UNITED STATES PATENT AND TRADEMARK OFFICE

Office Action Summary	Application No. 10/598,436	Applicant(s) OH ET AL.	
	Examiner JUSTIN LOFFREDO	Art Unit 3744

DETAILED ACTION

Rode – Figure 3**FIG. 3**

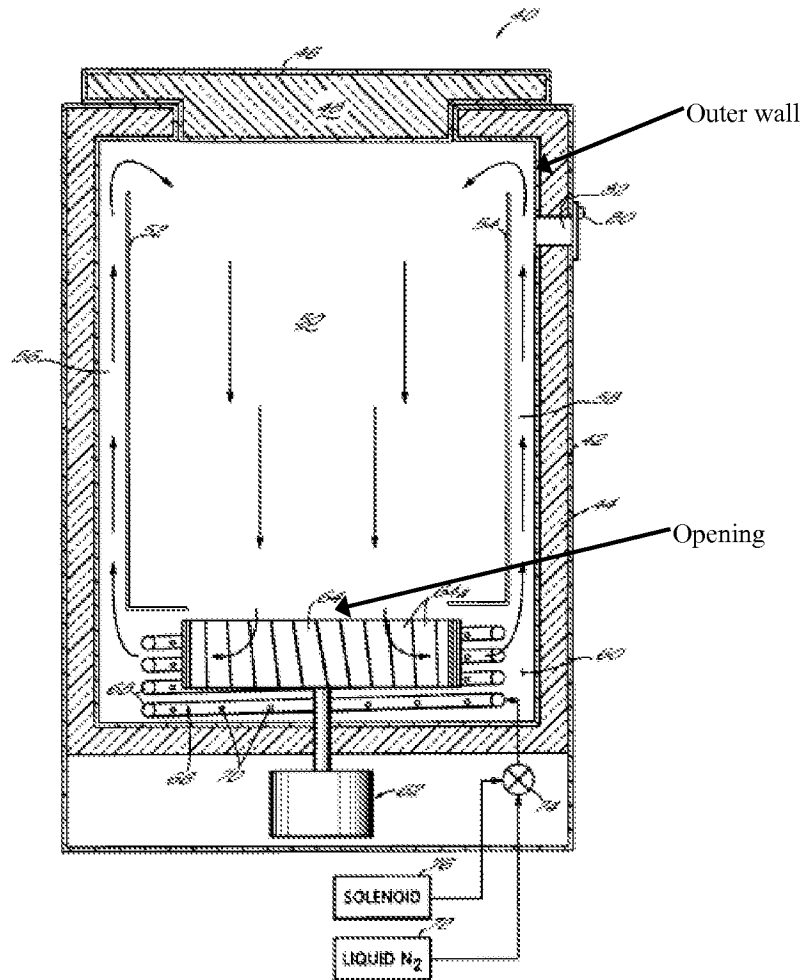
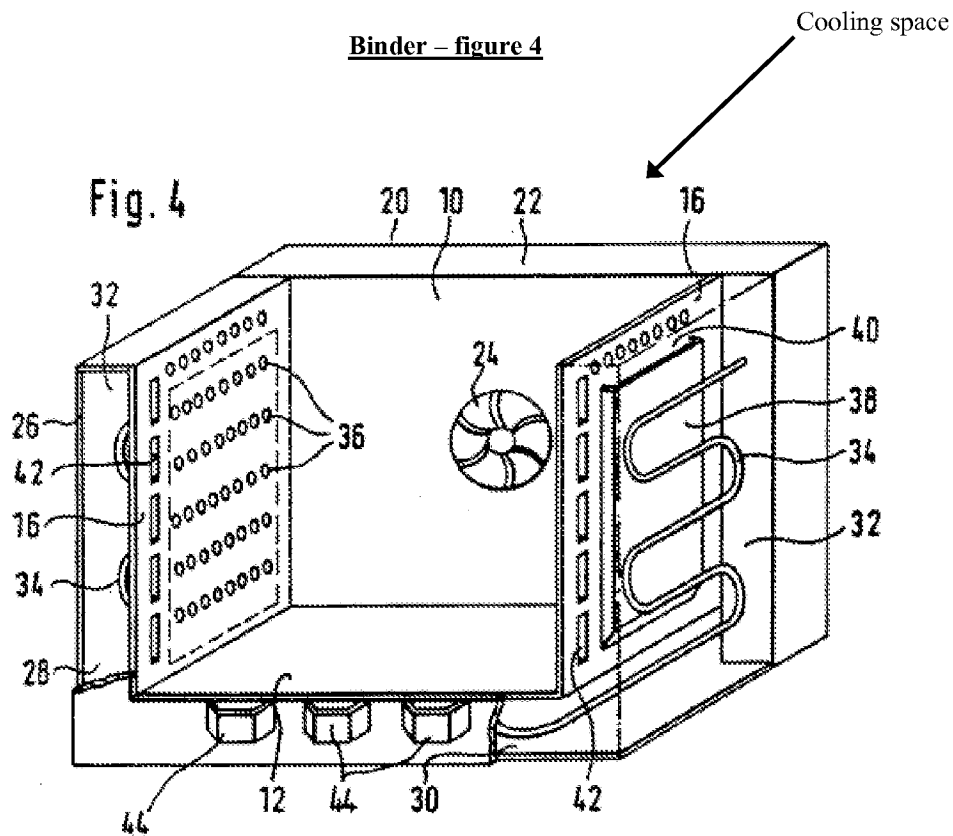
Consider claim 21. Rode discloses cooling equipment (40) for cooling a cooled material, said cooling equipment comprising: a cooling space (50) capable of receiving the cooled material; inner walls (52) and (54) limiting the cooling space (50); a lid (46); an outer wall (see Figure 3 below); plenums (56), (58) and (60), which make up the claimed intermediate space

between the outer wall and the inner walls (52) and (54); and a perforated tube (66) (corresponding to the claimed cooling agent supply line) communicating with and emptying into the intermediate space for introducing a cooling agent, whereby most of the liquid cooling agent (i.e. not all of the liquid cooling agent is necessarily vaporized, and thus, some of the liquid cooling agent is introduced in the intermediate space (see col. 1, L 59-col.2, L 7)), wherein the cooling agent supply line (66) empties into the intermediate space between the inner walls (52) and (54) and the outer wall, and continuously transfers the cooling agent into the cooling space (col. 3, L 10-48; Fig. 3).

Rode fails to disclose a porous buffer material arranged in the intermediate space; the cooling agent supply line introducing the cooling agent into the porous buffer material; the cooling agent being transferred from the buffer material through the inner wall with the inner wall being permeable; and the ability of the cooling equipment to function without a cooling agent lake forming on a bottom of the cooling space. Roslonski teaches a porous buffer material (34) arranged in an outer compartment (32) (corresponding to the claimed intermediate space), and an inner wall (20) having holes (36) (corresponding to the claim that the inner wall is permeable) (col. 2, L 24-71; Fig. 2). It would have been obvious to one of ordinary skill in the art at the time of the invention to modify the cooling equipment disclosed by Rode to also incorporate the porous buffer material arranged in the intermediate space and the inner wall being permeable as taught by Roslonski so that the cooling agent supply line introduces the cooling agent into the porous buffer material to then transfer the cooling agent from the buffer material through the inner wall, in order to effectively insulate and maintain a reduced temperature in the cooling space while distributing the cooling agent to pass through the

permeable inner wall into the cooling space. Furthermore, the presence of the porous buffer material would capture liquid refrigerant flowing through the intermediate space not vaporized in the cooling agent supply line, thereby preventing the formation of a cooling agent lake at the bottom of the cooling space. Additionally, while it does appear that a cooling agent lake could form within plenum (60) around the coil (68), claim 21 recites that “no cooling agent lake forms on a bottom of *the cooling space*” (lines 13-14). The opening provided at the bottom of the cooling space (50) of the apparatus disclosed by Rode would prevent the formation of a cooling agent lake at the bottom of the cooling space as recited in the claim (see Rode, annotated Fig. 3).
